HARTING Product Change Notification

PCN/18/014/C+N

Product range: DC1 / D-Sub

Title: D-Sub hoods with straight cable entry and screw locking - External

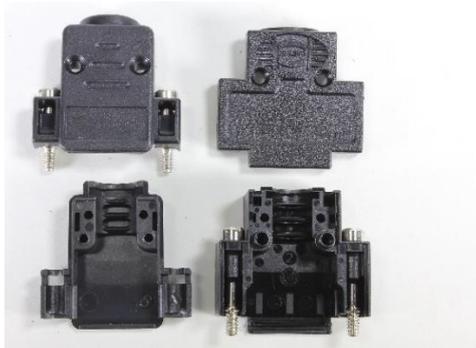
- Locking screw preassembly

Old: locking screw preassembled in the cover

New: locking screw preassembled in the hood

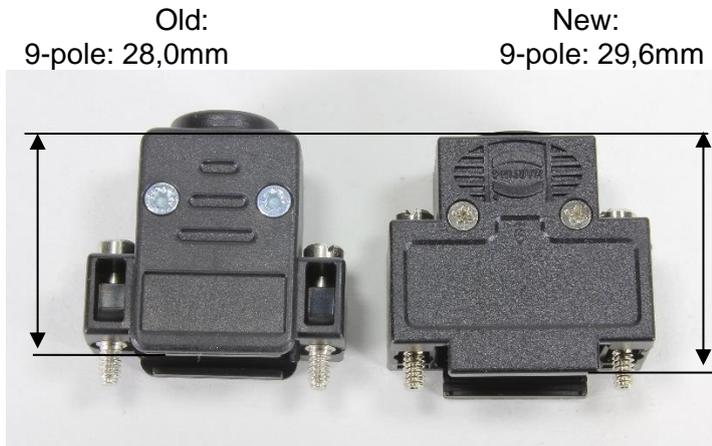
- Hood dimensions:
The overall shape of the hood and the size will not be changed except a small increase due to the second slit, which gives the possibility to use optional a new coding system in the future.

- Preparation for coding system:
In the future HARTING will announce a new coding system. The new hoods are already prepared for the use with the new coding system and the same hoods can also be used without coding system.

First slit for the fixing of the connector

Second slit for future coding system
